Appl. No. 10/537,544  
Amdt. dated August 24, 2007  
Reply to Office action of May 25, 2007

**AMENDMENTS TO THE DRAWINGS**

Fig. 2

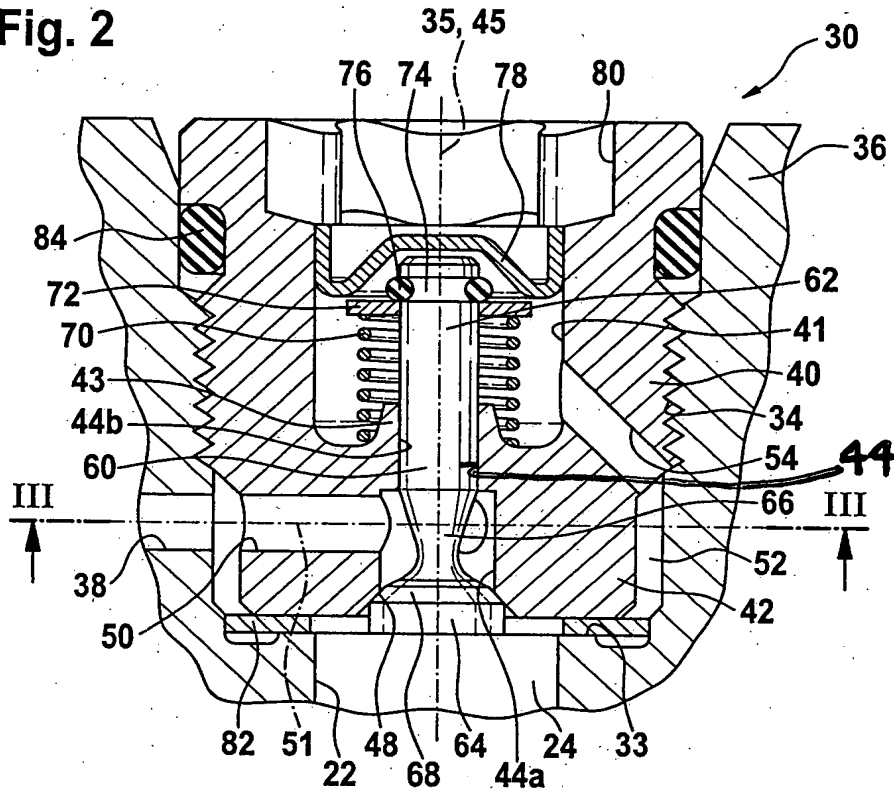
The attached replacement sheet of drawings includes changes to Figs. 2 and 3. The replacement sheet, which includes Figs. 2 and 3, replaces the original sheet including Figs. 2 and 3. In Fig. 2, reference numeral "44" and in Fig. 3, section line IV-IV have been added.

The drawings have been objected to because reference numeral "44" is missing. Fig. 2 has been amended to include Fig. 2. Also, the section line IV-IV, referred to in paragraph [0008] of the specification, has been added. Accordingly, withdrawal of the objection is requested.
